SP2019-022

The Lakes Assembly

SP2019-022 Site Plan for The Lakes Assembly: Please address the following comments (M= Mandatory Comments; I = Informational Comments)

**CASE NUMBER:** SP2019-022; Site Plan for House of Worship

THE LAKES ASSEMBI ROCKWALL, TEXAS Z

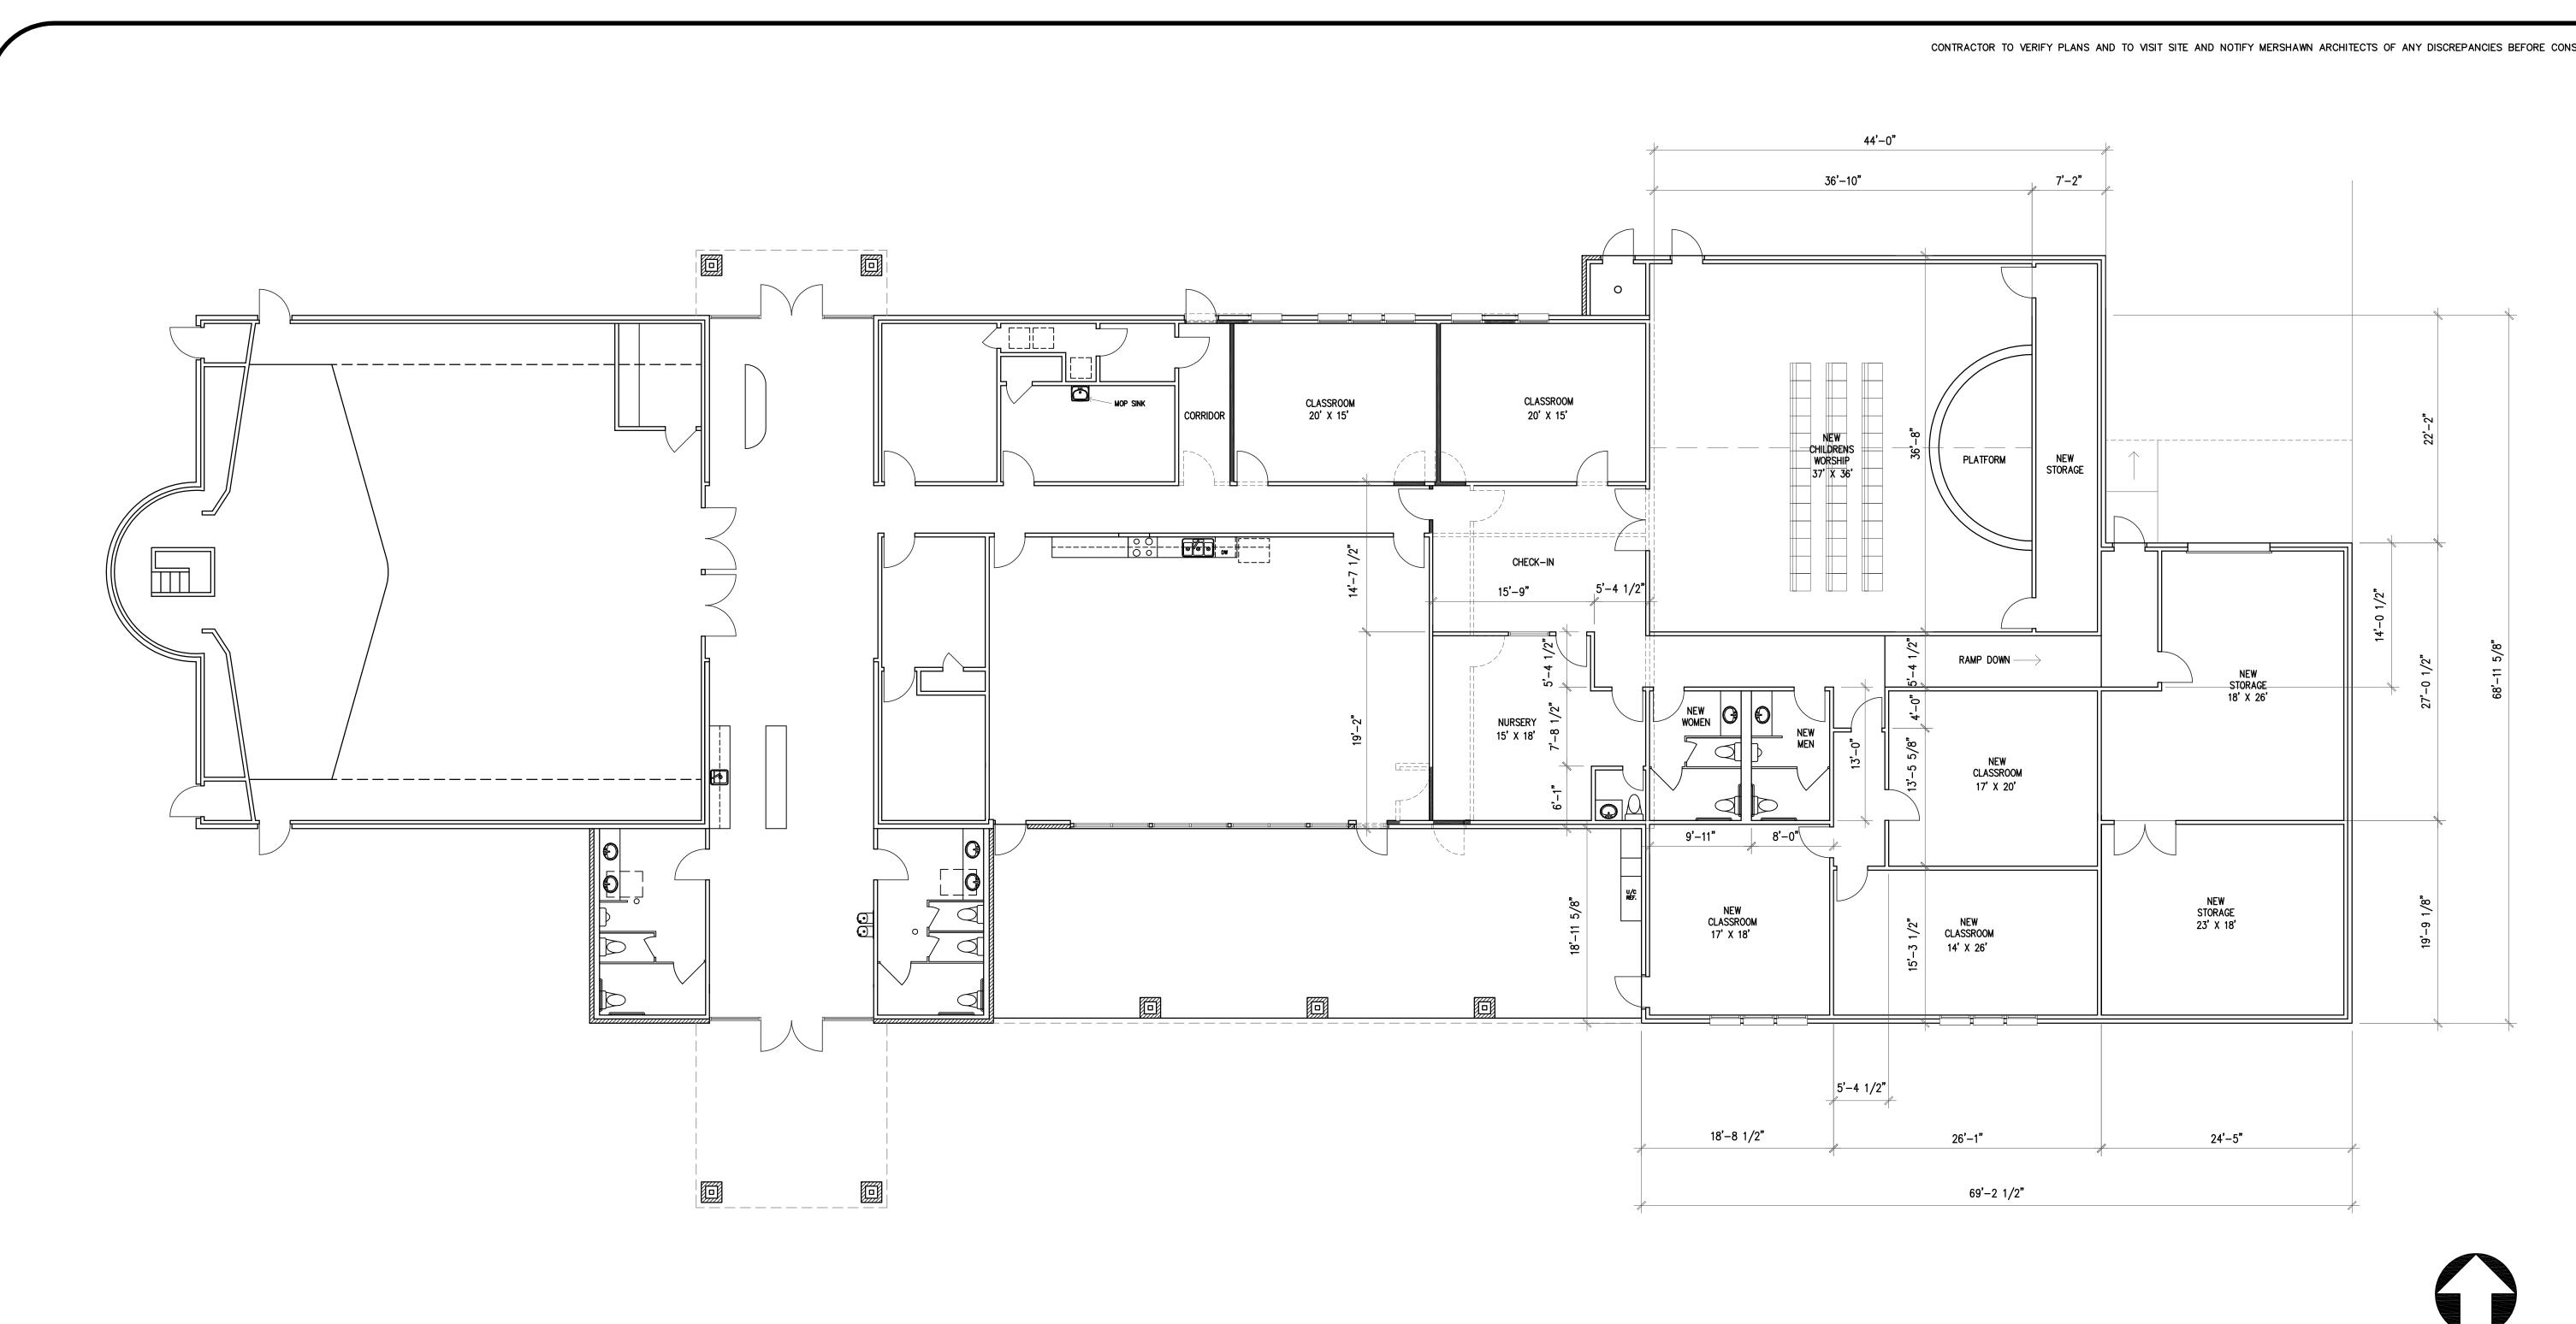
- 3. For reference, include the case number (SP2019-022) in the lower right hand corner of all pages on future submittals.
- 4. Site Plan--Will any additional exterior lighting be added?

- 5. Site Plan--Is additional parking being added?
- 6. Site Plan--Please show landscape buffer and setback adjacent to SH-66
- 7. Site Plan--Please dimension all walls

- 8. Site Plan—Please provide a light crosshatch to the existing areas.
- 9. Site Plan--Please provide a floorplan to indicate the use of the addition to ensure the parking requirement is accurate.

- 10. Site Plan--Please show and label where the mechanical equipment is and how it will be screened?
- 11. Site Plan--Please show centerline of SH-66
- 12. Site Plan--Please provide total number of seat and breakdown of existing building.

- 13. Site Plan--Please provide width of drive and radii
- 14. Site Plan--Please provide lot information on within the lot (e.g. SF, acreage, zoning, legal description, etc).

- 15. Site Plan--Please increase the font size of the items labeled on the site. Also, please note that the accessible symbols are blurry.
- 16. Site Plan--Please show and label adjacent properties.

- 17. Site Plan--Please note that a 10-foot landscape buffer including headlight screening is required along the property lines that are adjacent to residential.

- 18. Site Plan--Asshown, an exception to the horizontal articulation requirements is needed on the south elevation of the addition.
- 19. Site Plan—Please show all easements.

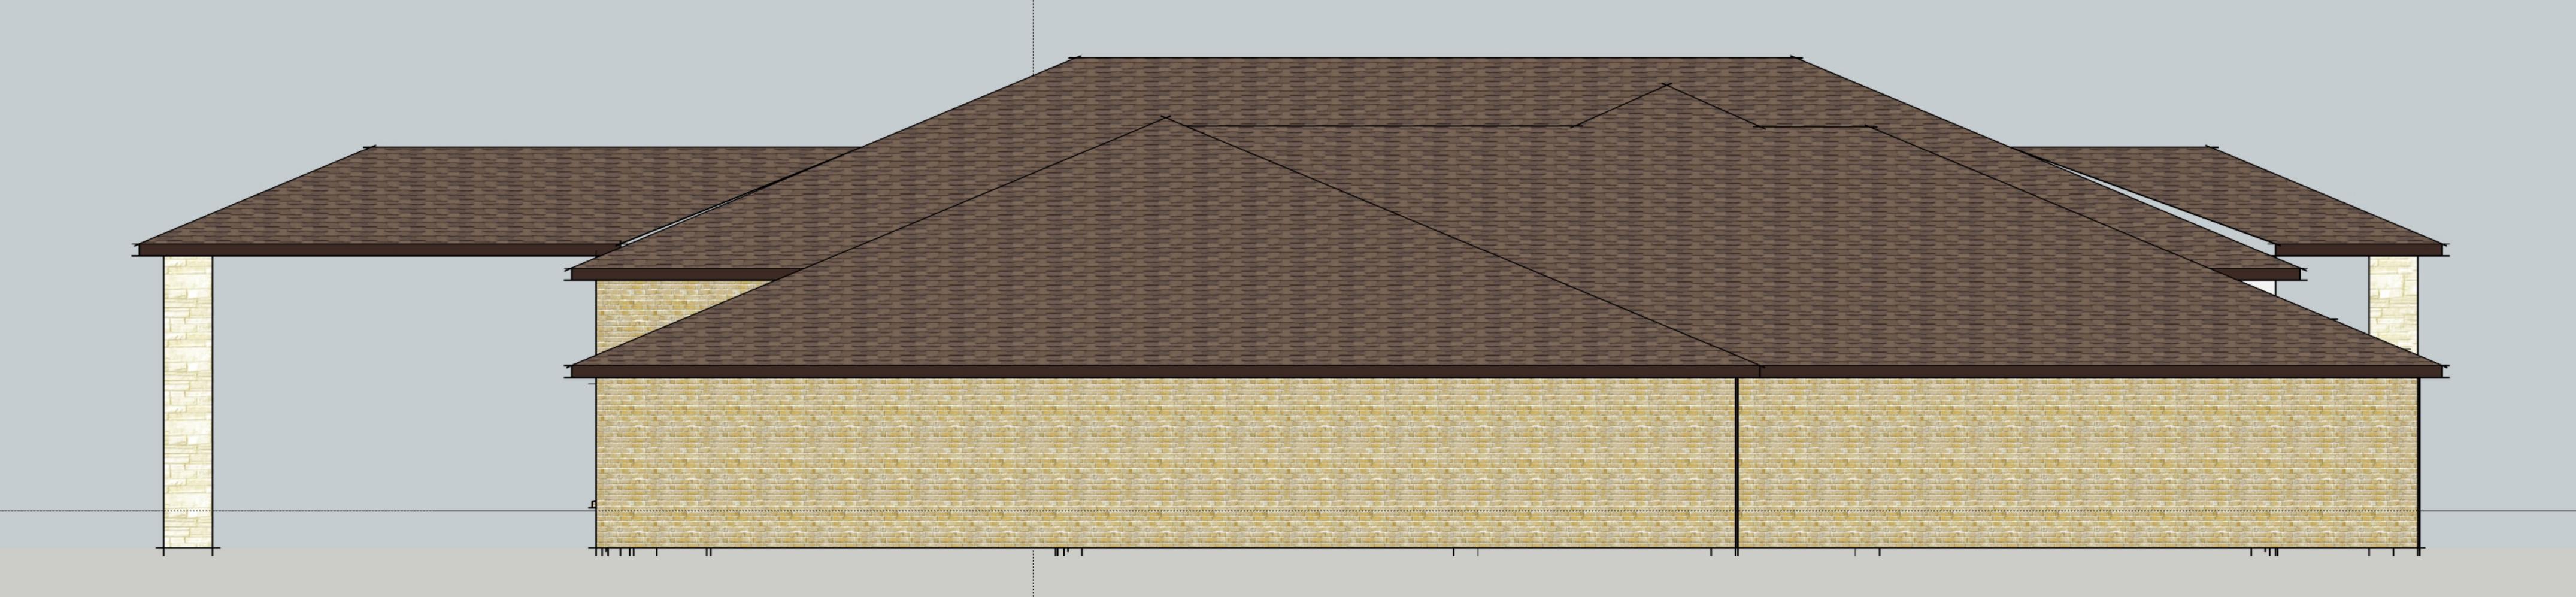
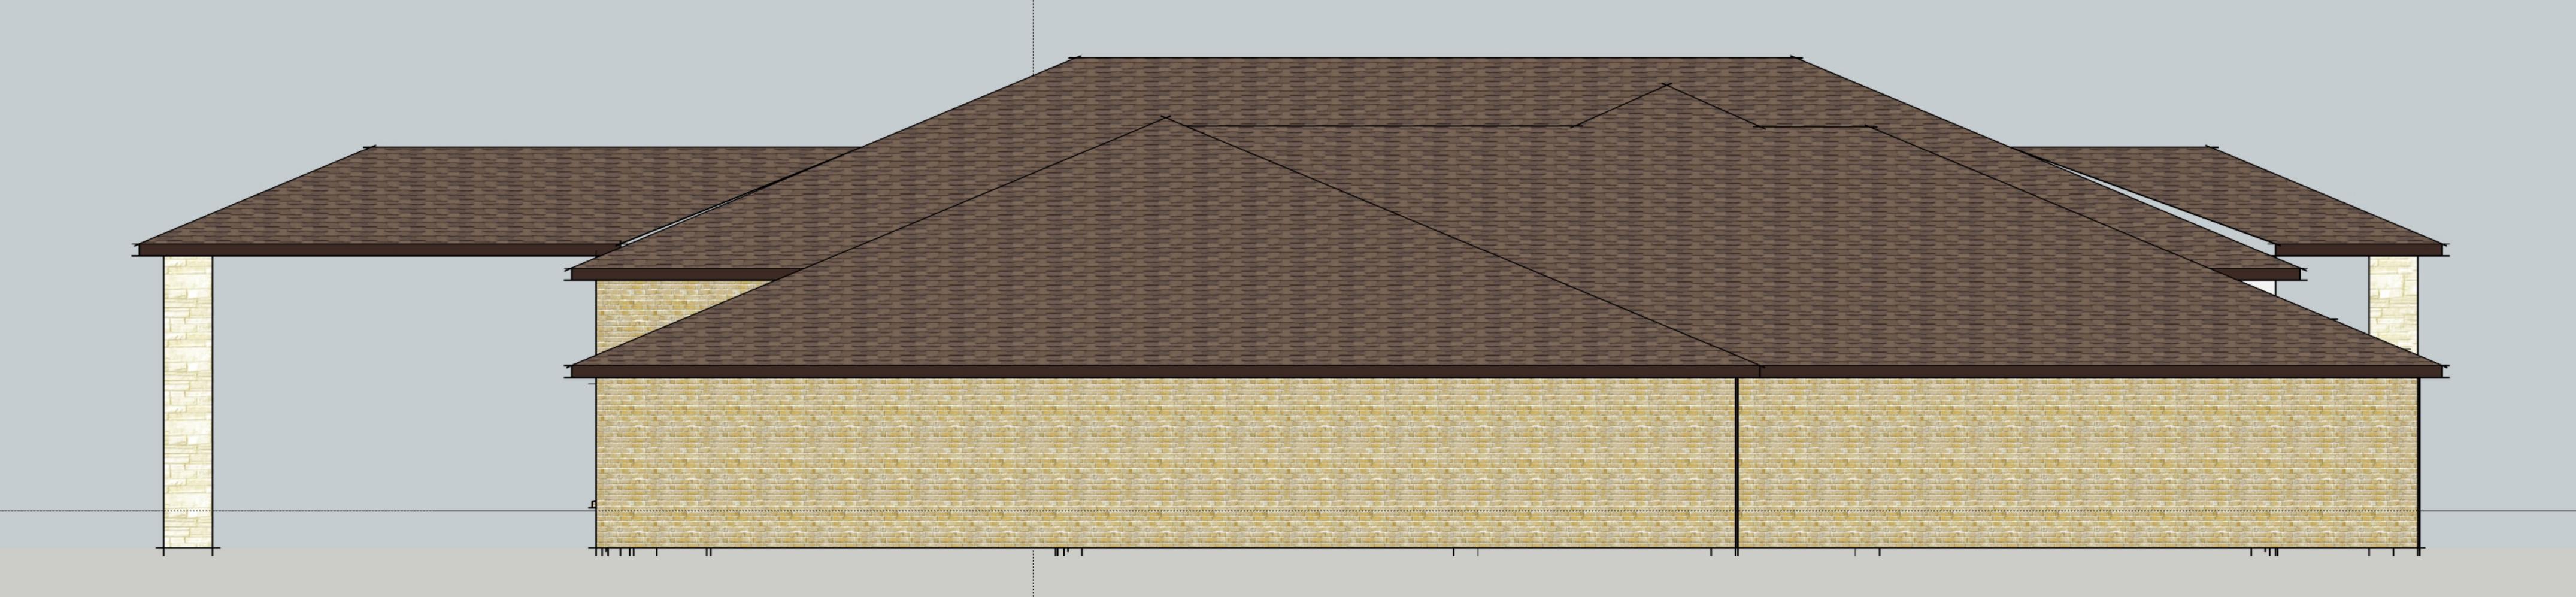
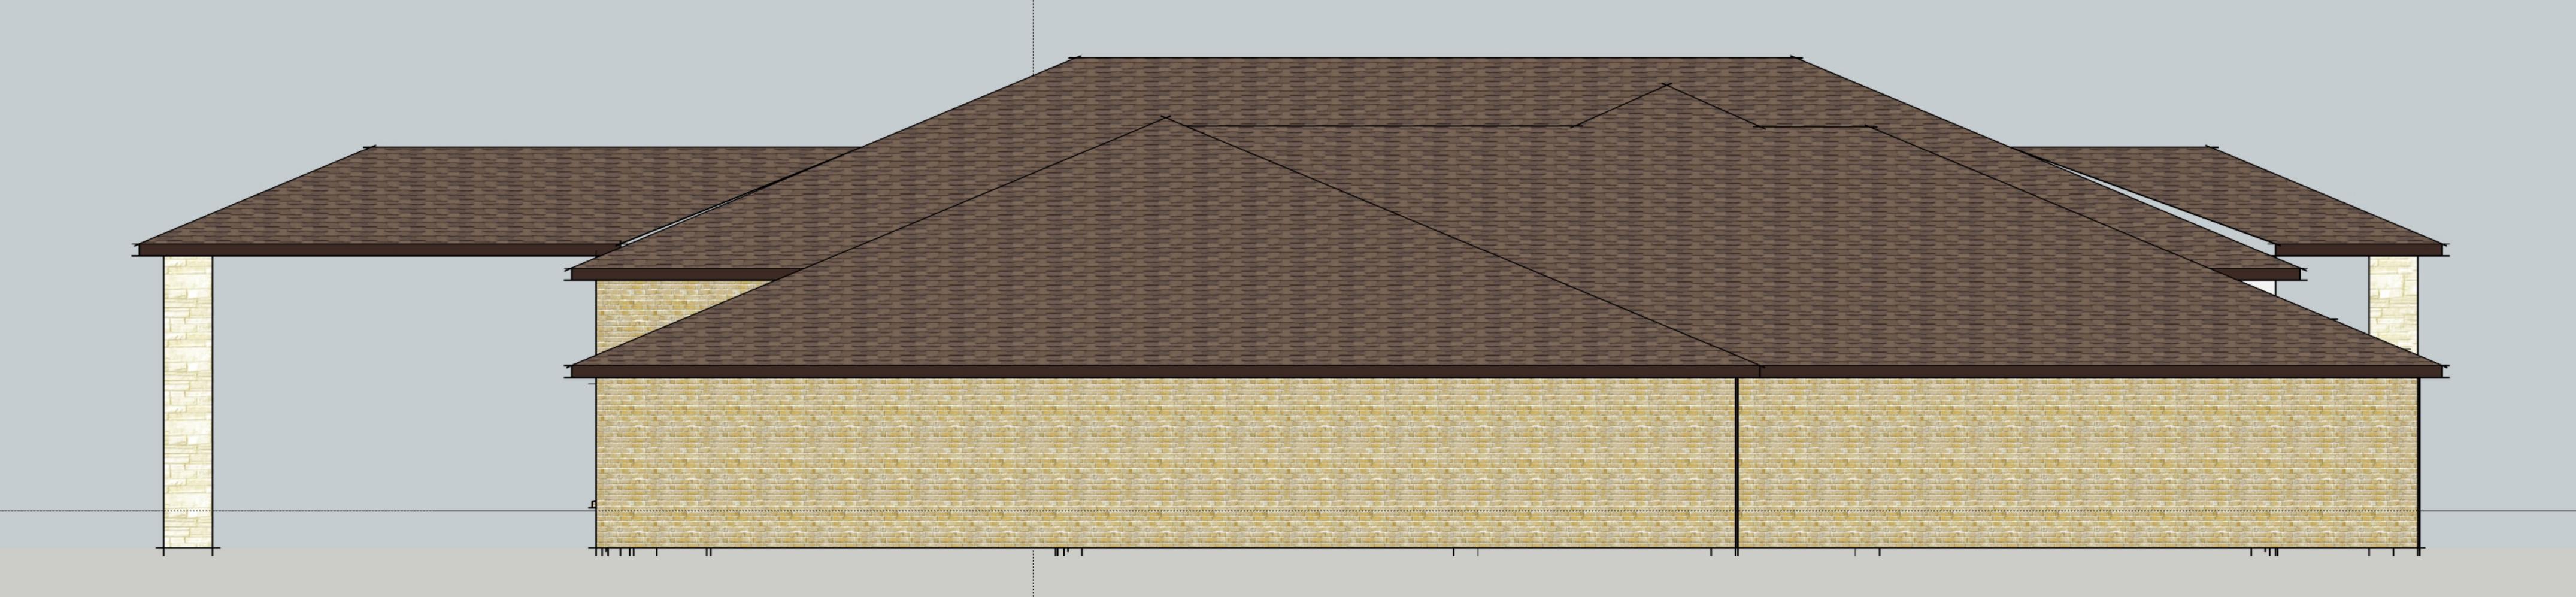
- 28. Landscape Plan—Please show vicinity map and the other labels as the site plan (e.g. label SH-66, etc.)
- 29. Building Elevations—Please provide the west elevation and indicate which elevation faces the street.

- 30. Building Elevations—Please provide dimension, heights, scale, etc.
- 31. Building Elevations—It appears that the ease elevation may be a different scale than the others. Please provide all 4 elevations at the same scale.

- 32. Building Elevations—Please note that a variance to horizontal articulation will be required for the south elevation of the addition.
- 33. Building Elevations—Would it be possible to provide an additional elevations page that shows existing greyed out? It is difficult to understand where the addition starts.

- 34. Building Elevations—Please provide shadows to show where projections, recesses are.
- 35. Building Elevations—Please take a look at the east elevation-it appears that there may be a discrepancy in the roofline.

- 36. Building Elevations—Please take a look at the north elevation. There appears to be some extra lines in the roof (right below the two labels for the roof).

37. Building Elevations—Please show and label where the mechanical equipment is and how it will be screened?

- 38. Building Elevations—Please show building materials and percentages.
- 39. Staff has identified the aforementioned items necessary to continue the submittal process. Please make these revisions and corrections, and provide any additional information that is requested. Revisions for this case will be due on July 2, 2019. The Planning and Zoning Worksession is on June 25th, 2019. The Planning and Zoning Meeting will be July 9th, 2019. Both meetings start at 6:00 p.m. The ARB meetings will be at 5:00 p.m. on the meeting dates.
